V2500 Propulsion System — Nacelle

SERVICE BULLETIN

Subject: Transmittal of Revision 1 to Service Bulletin Number V2500-NAC-29-0002

NACELLE - HYDRAULICS - HYDRAULIC FILTER MOUNTING RAFT - IDENTIFICATION PLATE -
INSTALLATION OF

Location of the Mounting Raft for the Fin Plate
Figure 1

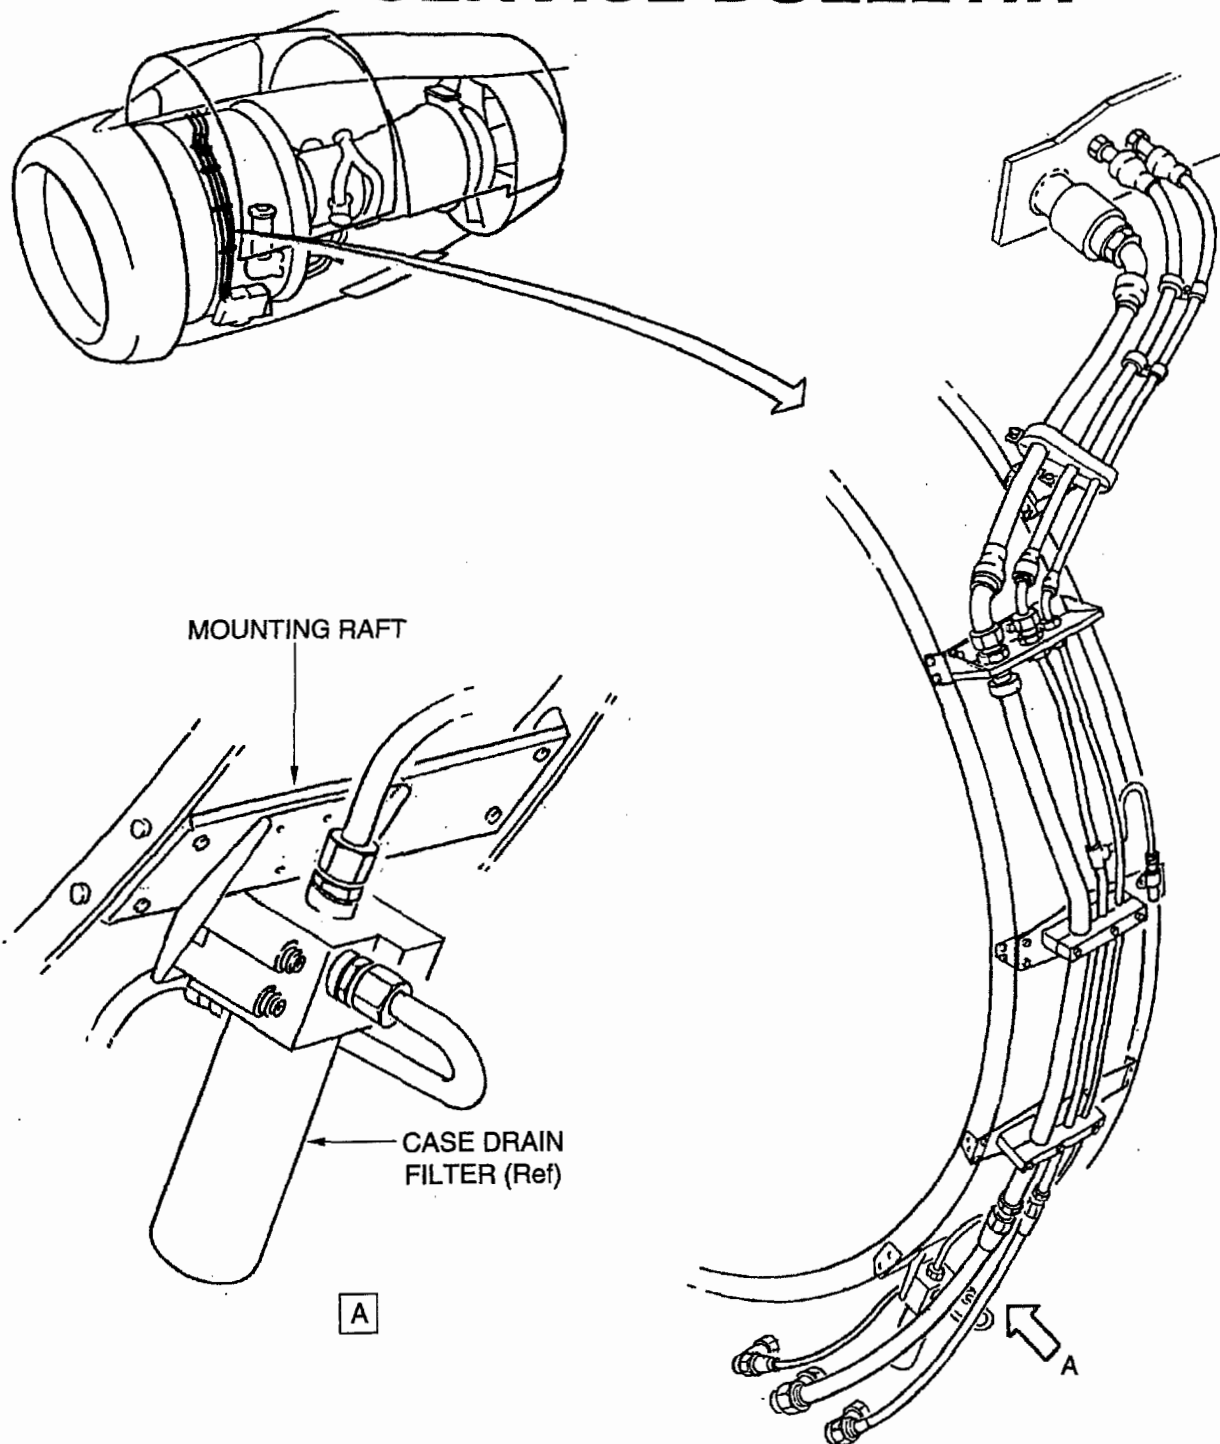
- (1) Put the 740-0296-505 fin plate into position on the 740-5601-505 raft assembly. Make a mark for the four rivet holes in the fin plate. Remove the fin plate. Refer to Figures 1 and 2.
- (2) Drill four 0.159 inch (4,05 mm) holes in the 740-5601-505 raft assembly. Remove the burrs from the holes.
- (3) Install the 740-0296-505 fin plate on the 740-5601-505 raft assembly with the four MS20615-4M5 rivets. Refer to Figure 2.
- (4) Re-identify the raft assembly as part number 740-5601-507 with a rubber stamp and ink (CoMat 06-073). Refer to the IAE V2500 Standard Practices/Processes Manual, Chapter 70-09-00.

Installation of the Fin Plate
Figure 2

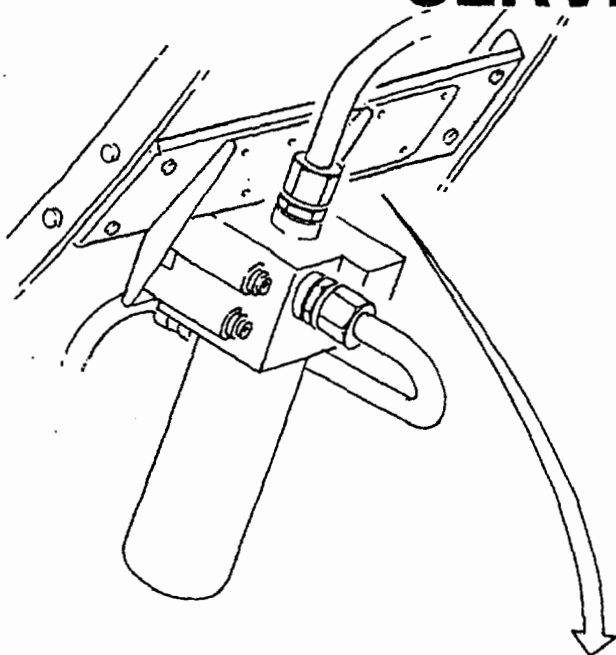
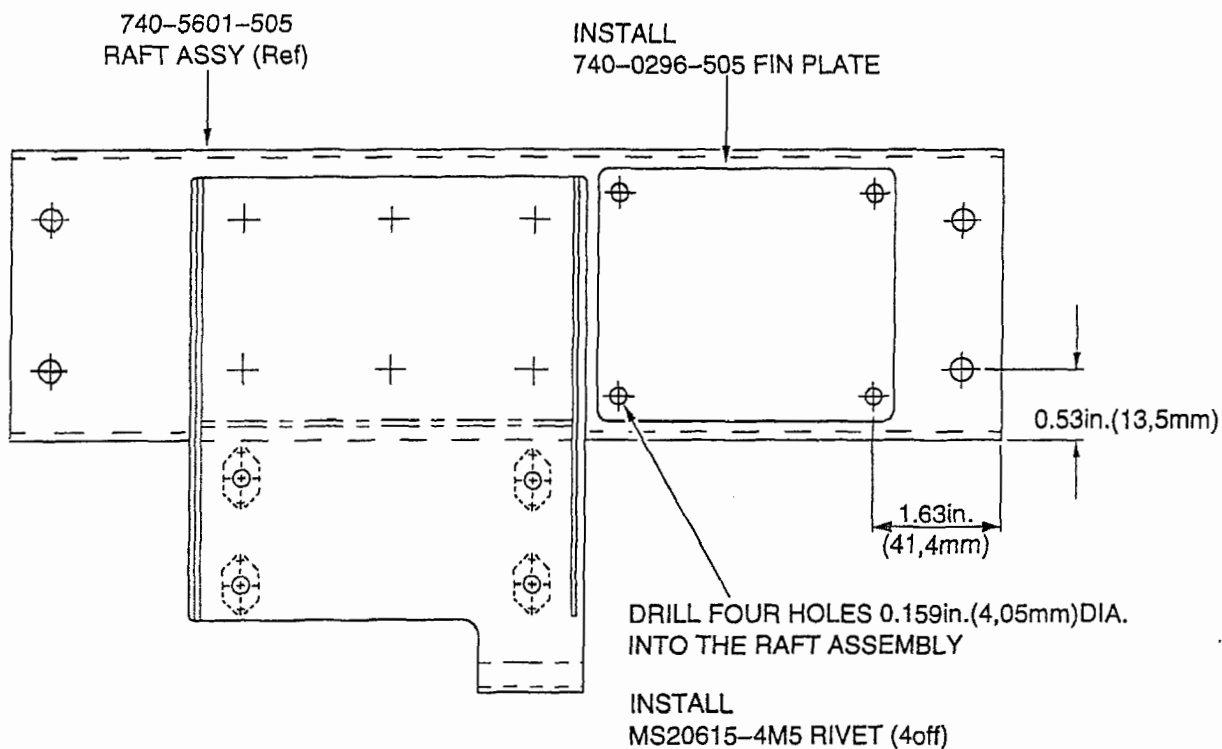
NOTE: Install the fin plate.
Reidentify the raft assembly as
part number 740-5601-507
